U.S. Department
of Transportation
**Federal Highway
Administration**

Subject: INFORMATION: Modified Oregon 2-Tube Bridge
Rail/Acceptance Letter B-121

Date: July 25, 2003

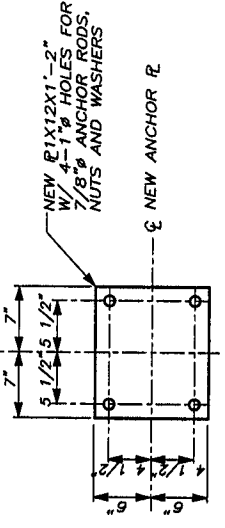
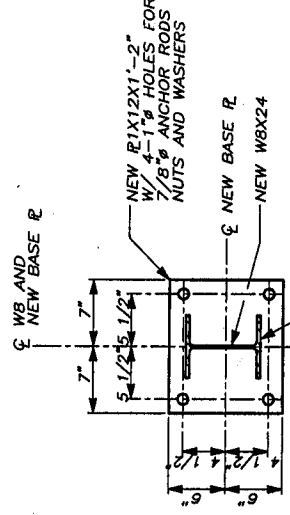
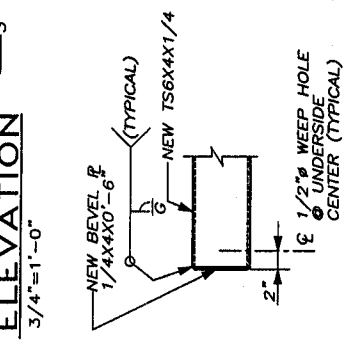
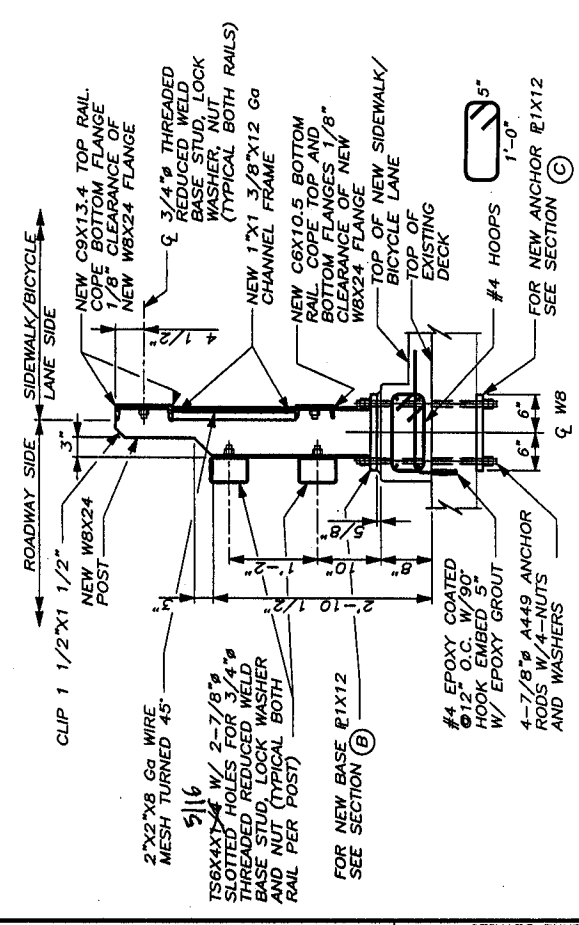
Two of the issues identified in your letter bear repeating. First, the calculations accompanying your request were based on a rail thickness of 5/16 inch, not 1/4 inch, and the drawing must be revised to show the greater thickness. Second, the sloped end terminal design is not crashworthy and its use is limited to locations where posted speed limits do not exceed 40 mph. An alternative treatment would be to terminate the sloped section when it reaches a height equal to that of an approach rail and use a crashworthy transition design to connect any approach rail to the concrete parapet.
